Mobile Intel[®] Pentium[®] 4 Processor-M

Specification Update

September 2004

Document Number: 250721-025

Figure 13. System Bus Reset and Configuration Timings

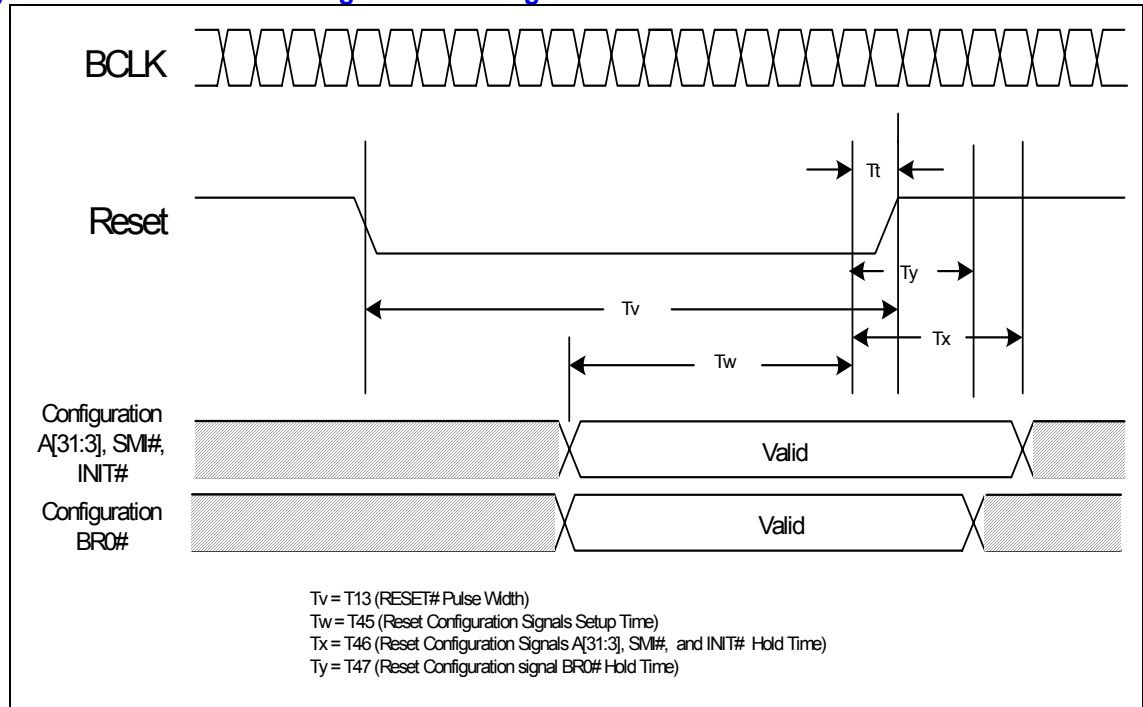
T2. BR0# Maximum Hold Time Specification Change

The BR0# maximum hold time has changed to 2 BCLKs. This change will be shown in the “System Bus AC Specifications (Reset Conditions)” table and “System Bus Reset and Configuration Timings” figure of the *Mobile Intel® Pentium® 4 Processor - M Datasheet*. This change will be incorporated in the next revision of the datasheet.

The following figure will be modified to reflect this change:

T# Parameter	Min	Max	Unit	Figure	Notes
T45: Reset Configuration Signals (A[31:3]#, BR0# INIT#, SMI#) Setup Time	4		BCLKs	13	1
T46: Reset Configuration Signals (A[31:3]#, INIT#, SMI#) Hold Time	2	20	BCLKs	13	2
T47: Reset Configuration Signal BR0# Hold Time	2	2	BCLKs	13	2
